CITY OF ALBUQUERQUE

RE: **Lot 3 Block 6 Unit 2 S.A.D. 227**
7909 Victoria NW
Grading and Drainage Plan
Engineers Stamp Date 7/18/18 (D10D048)

DRAINAGE AND TRANSPORTATION INFORMATION SHEET (REV 6/2018)

ENGINEER'S SEAL  7/18/18	7909 VICTORIA DRIVE	DRAWN BY DEM
DAVID SOULE P.E. #14522	GRADING AND DRAINAGE PLAN	DATE 7-17-18
 1608 CENTRAL AVENUE SE SUITE 201 ALBUQUERQUE, NM 87106 (505) 972-0899	SHEET # C1	JOB #

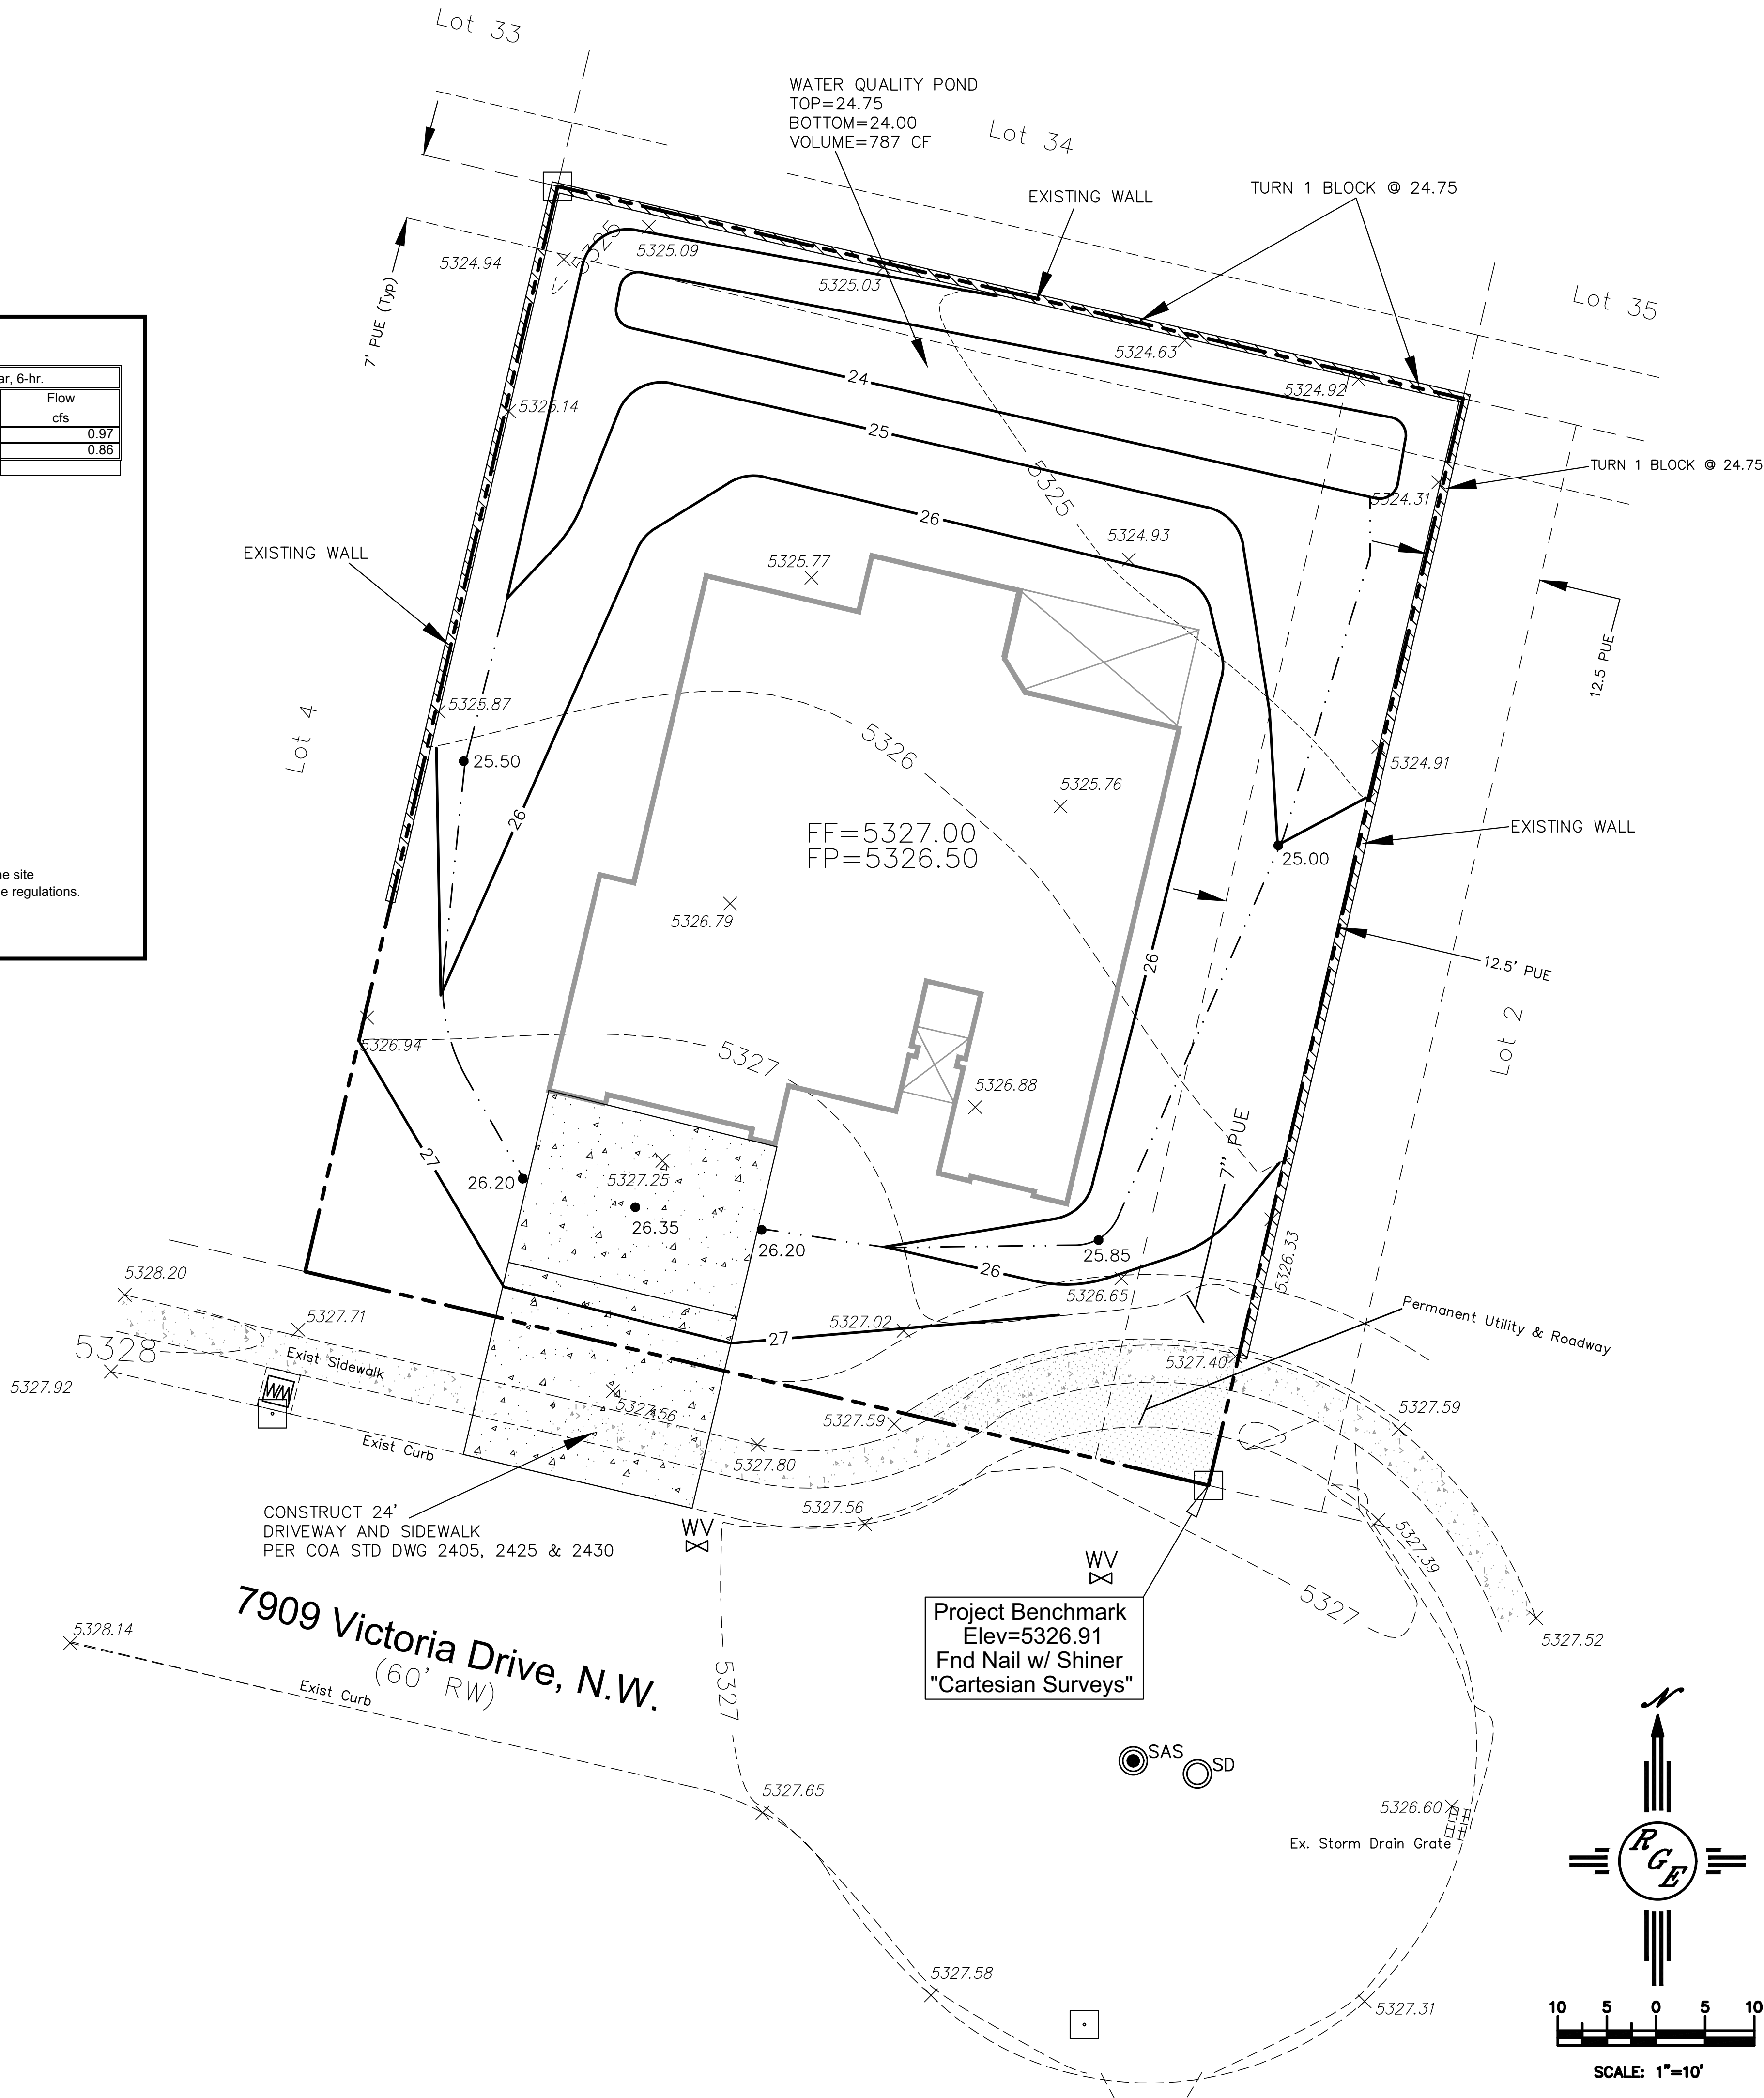
Based upon the information provided in your submittal received 7/18/18, this plan is approved for Grading Permit. Please inform the builder/owner to attach a copy of this approved plan and letter into the construction sets in the permitting process prior to sign-off by Hydrology.

Reiterate to the Owner/Contractor that a separate permit for a garden/retaining wall must be obtained, with the approved G&D plan.

Prior to Building Permit approval, a **Pad Certification** will be required.

Prior to **Certificate of Occupancy release**, Engineer Certification per the DPM checklist of this plan will be required.
